UNITED STATES  
NUCLEAR REGULATORY COMMISSION  
WASHINGTON, D. C. 20555

August 30, 1979

This will confirm my request to you on the telephone today that Babcock and Wilcox provide us with copies of the Site Problem Reports and Preliminary Safety Concerns listed below.

TITLE Pressurizer EMO Relief initted Inadvertently  
RELATED SPRs \_\_\_\_\_

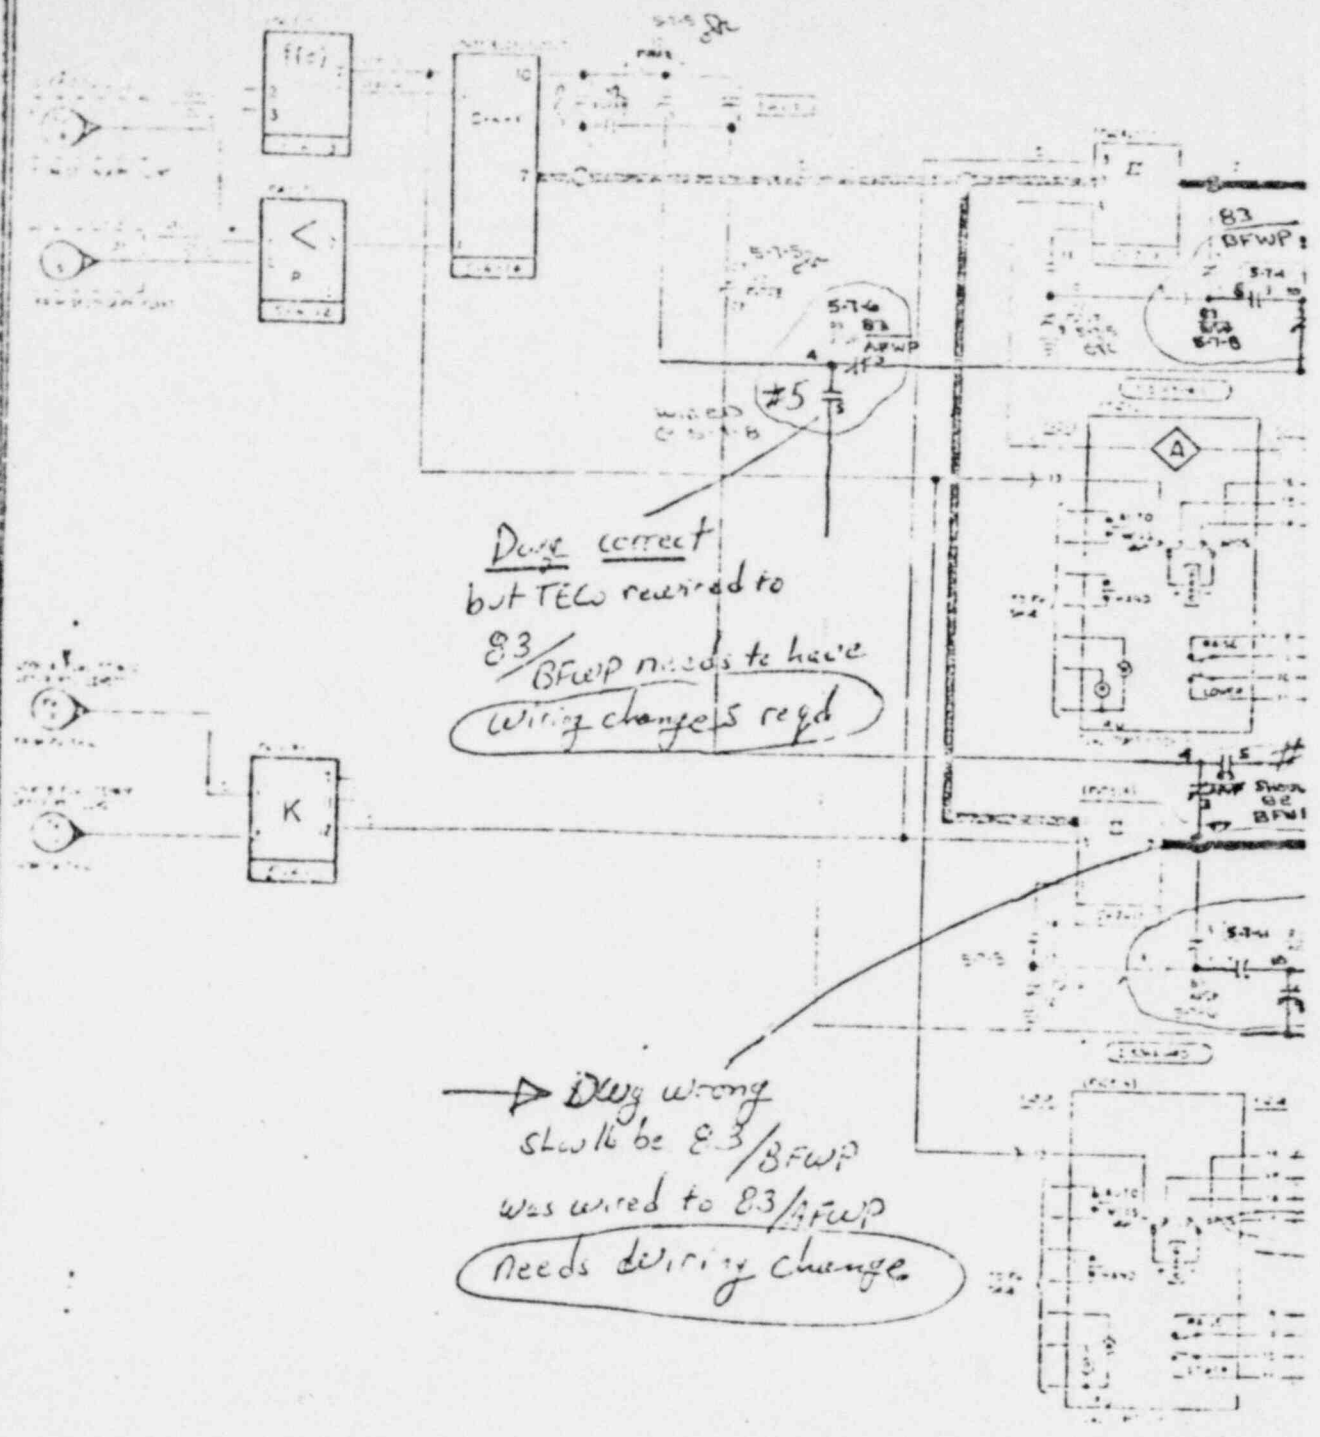
Checking logic makes it appear that the set towards the center of the drawing should be 83/BFWP, and the set towards the top left side should remain 83/APWP. However, the wiring was found to be in the reverse of this order.

The wiring of contacts 6, 7, 8, 9, 10, and 11 of 83/BFWP were found connected to 6, 7, 8, 9, 10, and 11 of 86/BFWPT. The wires that the drawing shows as going to 6, 7 and 8 of 86/BFWPT were, in turn, connected to 10, 13 and 14 of 86/BFWPT. There were no wires on 6, 7, 8, 9, 10, and 11 of 83/BFWP.

Loop 2 was found to have the same mistakes, involving the shift of wires from 83/APWP to 86/APWPT, the shift of wires from 6, 7, and 8 of 86/APWPT, and no wires on 6, 7, 8, 9, 10 and 11 of 83/APWP.

Dick Shaffer (BMC) and Fred Faist (B&W) contacted J. Courtwright (BMC) and T. Wolcott (B&W - Lynchburg). They reached a verbal agreement that the drawing be changed to show that contacts 3, 4 and 5 of 83/APWP towards the center should be 83/BFWP, and that the appropriate wiring changes be made to order.

It was also agreed, on that matter of the other wiring discrepancies, that the wiring be changed to match the drawing. The wiring changes were made and the field drawings corrected. The systems then functioned properly.

FIG. 5: Loop Feedwater Flows (vs. Time)

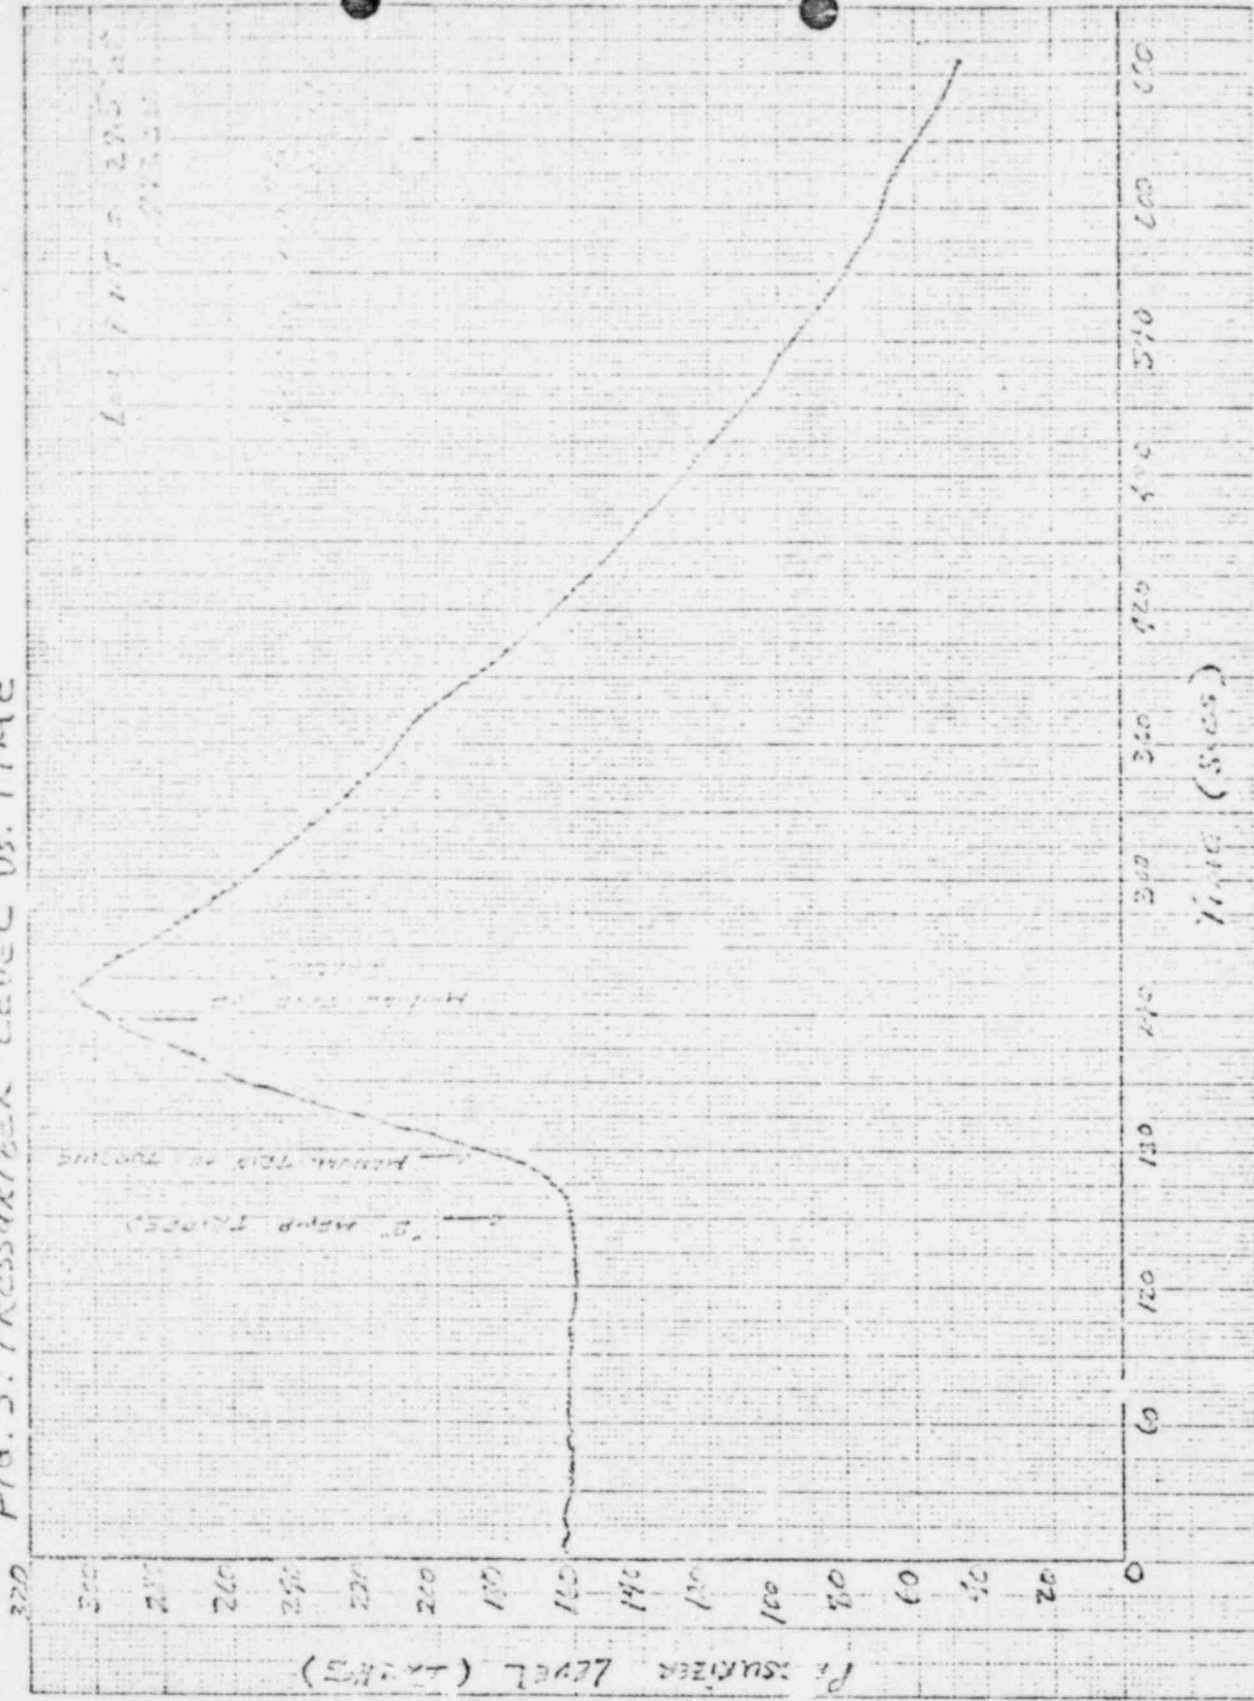
For the next several minutes, feedwater flow oscillated back-and-forth between the CDS'S. Figures 5 and 6 illustrate the back-and-forth feeding of the CDS'S. An explanation for this is the following:

1. Evaluate possibility for automatic reactor trip upon loss of all Feedwater Flow to prevent CDS'S from boiling dry.
2. Resolve, as soon as possible, the questions raised in SGM-90.

FIG. 4: TURBINE HEADER PRESSURE VS. TIME

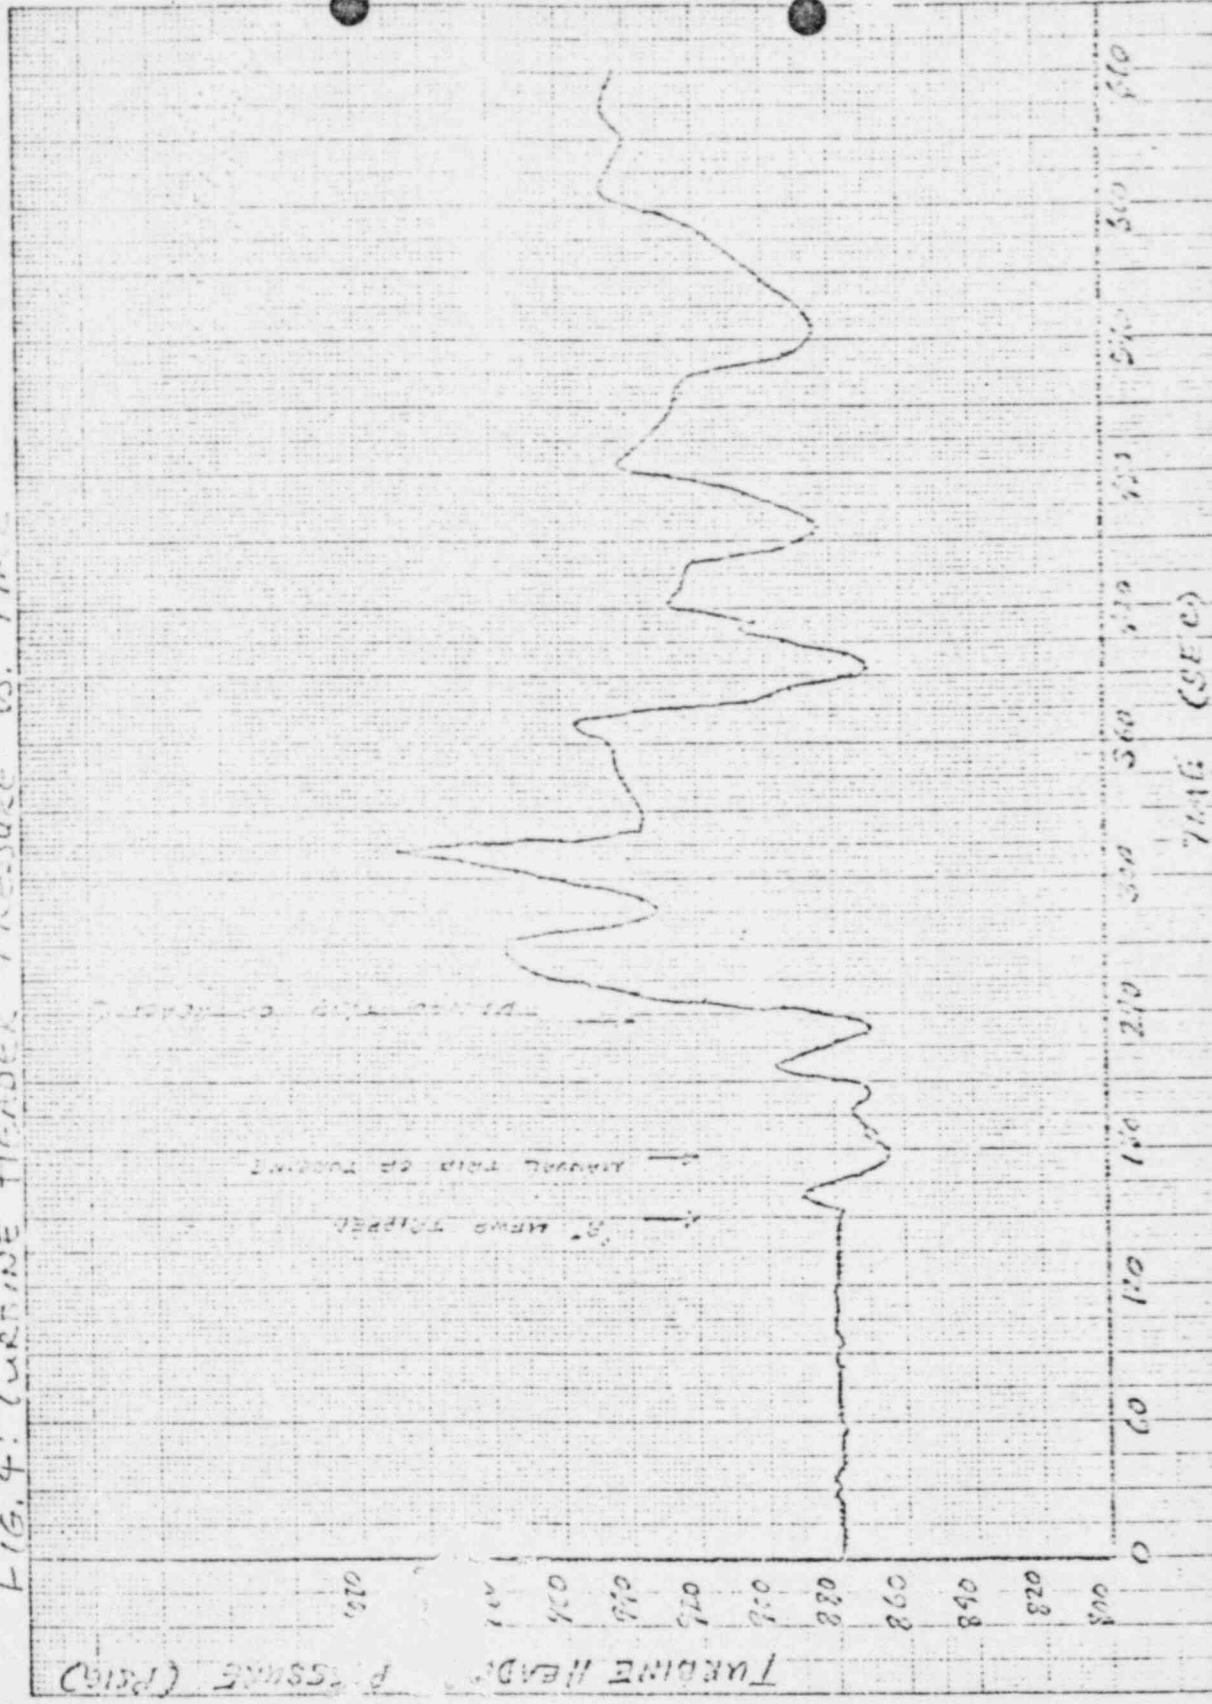
Immediately after the Reactor trip, Turbine Header Pressure began to increase above 800 psig because of the 105 psig bias placed on Turbine Header Pressure setpoint. However, as can be seen in Figure 4, Turbine Header Pressure only reached 975 psig before it began decreasing, indicating dry or nearly dry CDS'S.

FIG 1

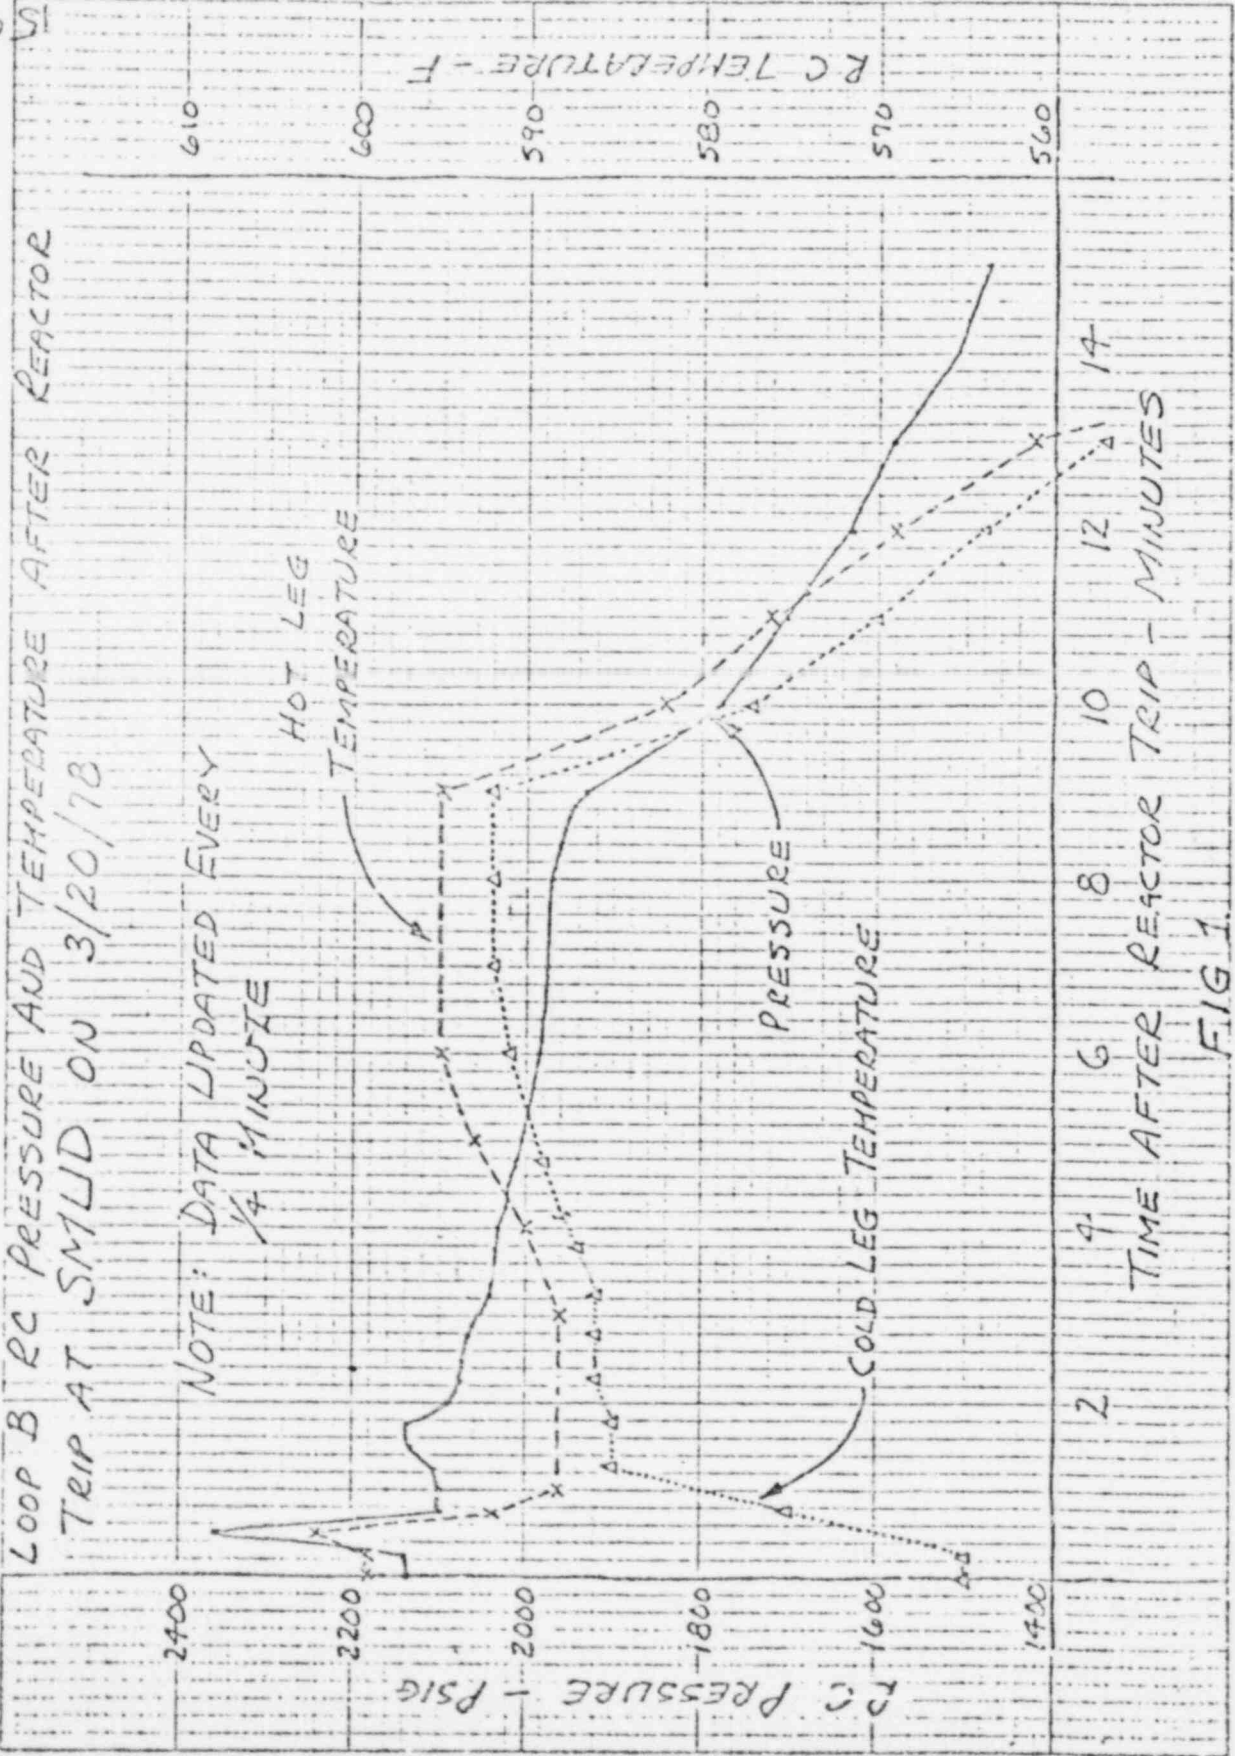
Figure 1 shows PC pressure and both a hot leg and cold leg temperature for the interval of time (13 minutes) between reactor trip and initiation of SFAS. Data was obtained from the Post Trip Review printout. At nine minutes increased cooldown of the PC system appears to be a result of the operator adding feed water to the loop A steam generator.

FIG 5

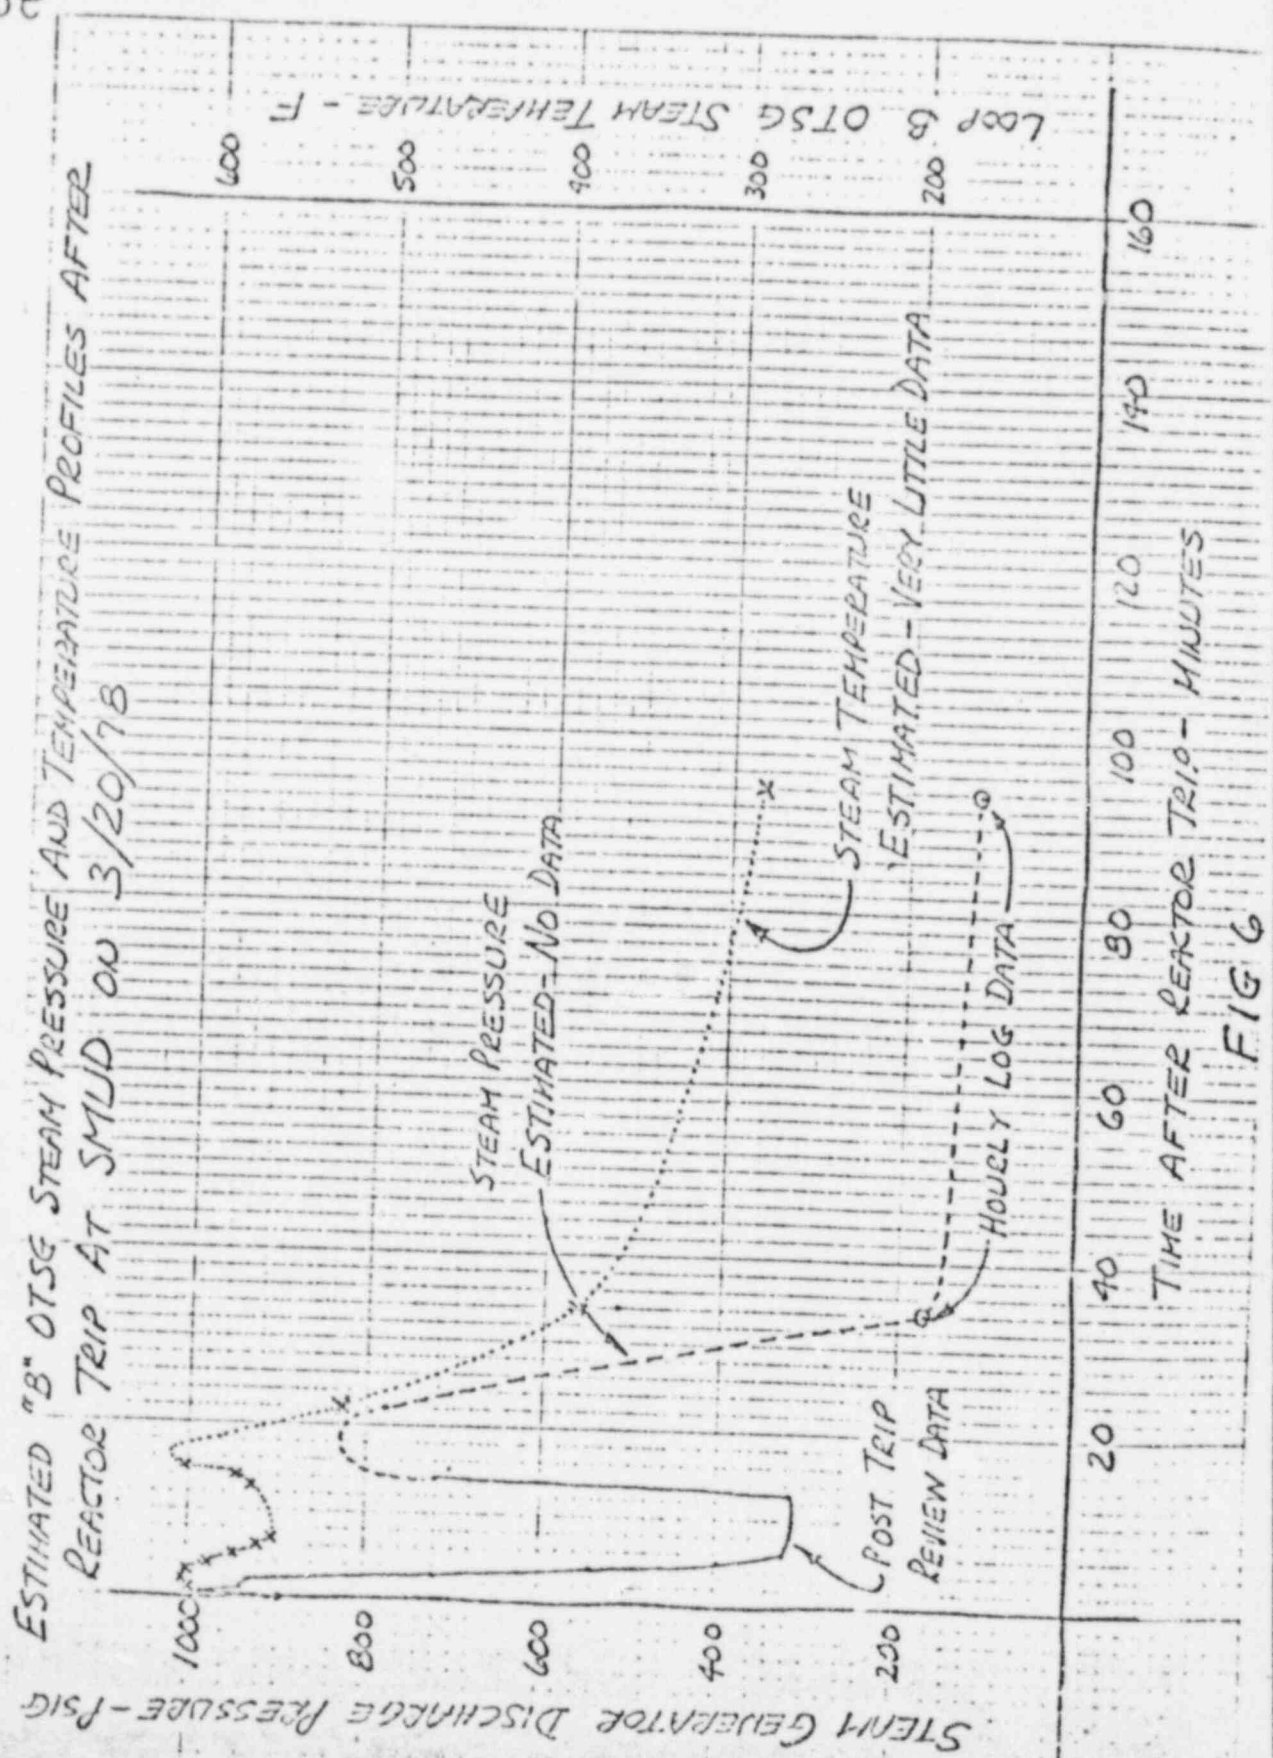
An Estimate of the change in RC temperature over a 3 hour period is shown in Figure 5. Two data sources were the Post Trip Review and the control room cold leg temperature recorder chart. At 25 minutes after the reactor trip RC temperature was below 520 F and the operator shutdown one RC pump. That is consistent with part of the data obtained from the 5 AM hourly log printout. The actual change in RC pressure temperature is probably less severe than shown as an estimate in Figure 5.
